ORIGINATION FORM

Proposed Revisions to a Standard Plans Index
(Please provide all information — Incomplete forms will be returned)

Index Number: 700-011
Sheet Number (s): 2 of 2
Index Title: Single Column Cantilever Ground Mounted Sign

BASE AND FOUNDATION DETAIL

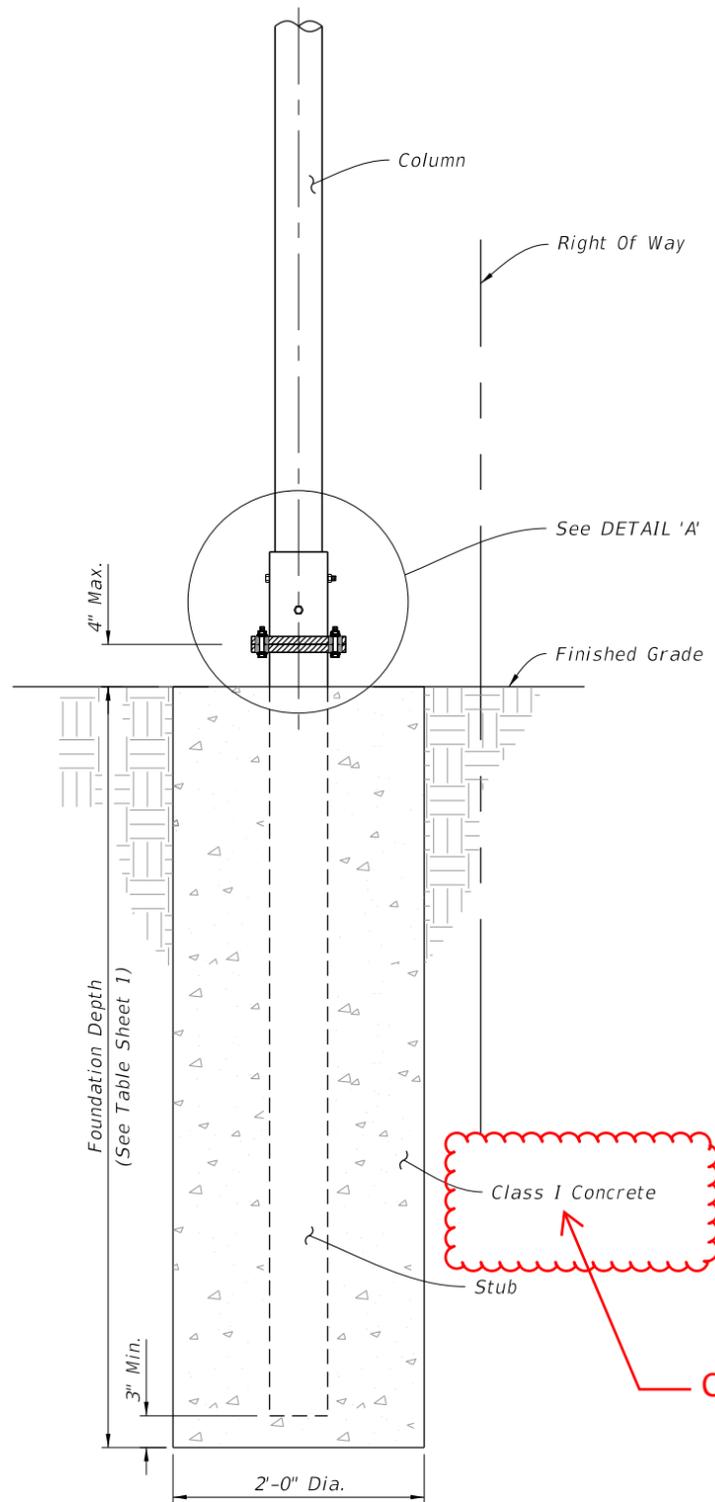
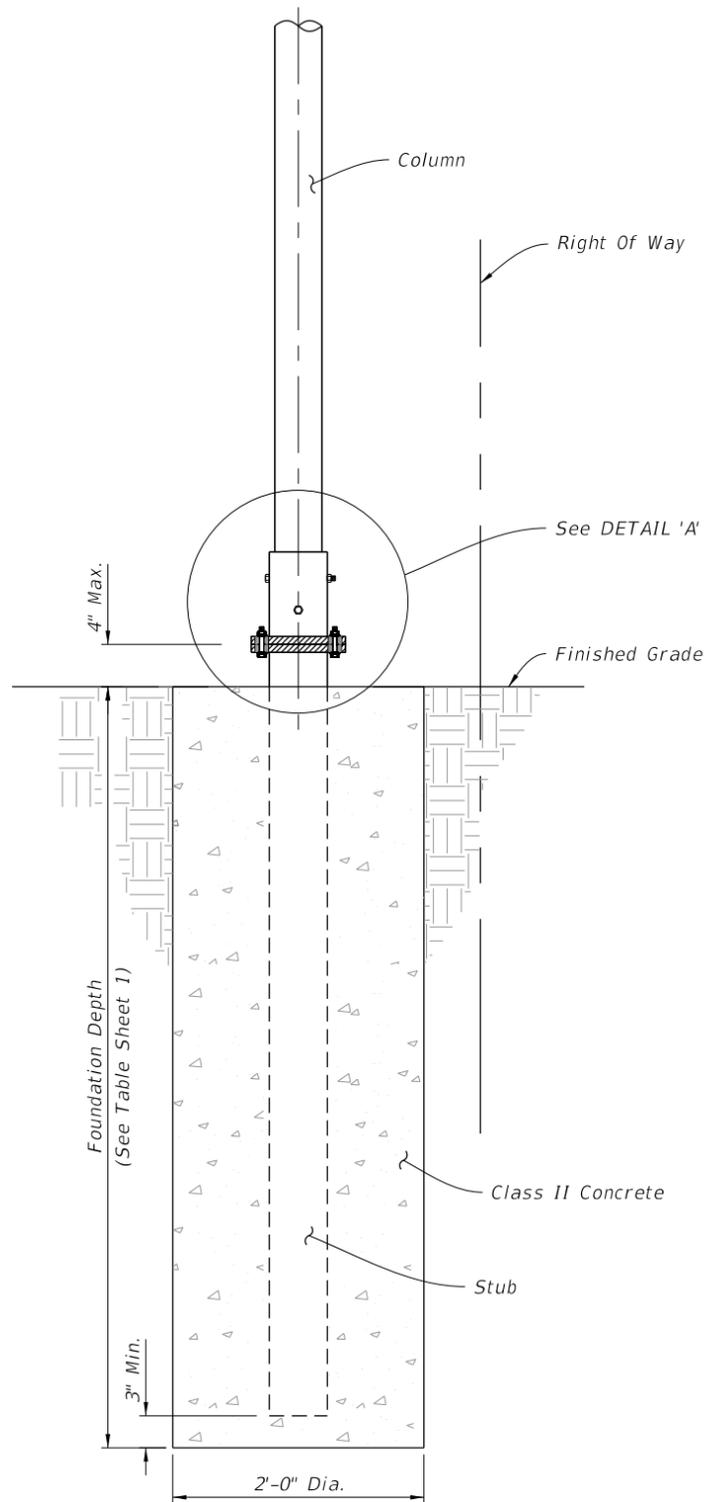
Sheet 2: Changed "Class I" to "Class II" in the BASE AND FOUNDATION DETAIL.

Changed to reflect Materials specification change that removes the designation for Class I Concrete.
Please see the attached Standard Specification Section 346 DRAFT for the Class I revisions proposed by the State Materials Office.
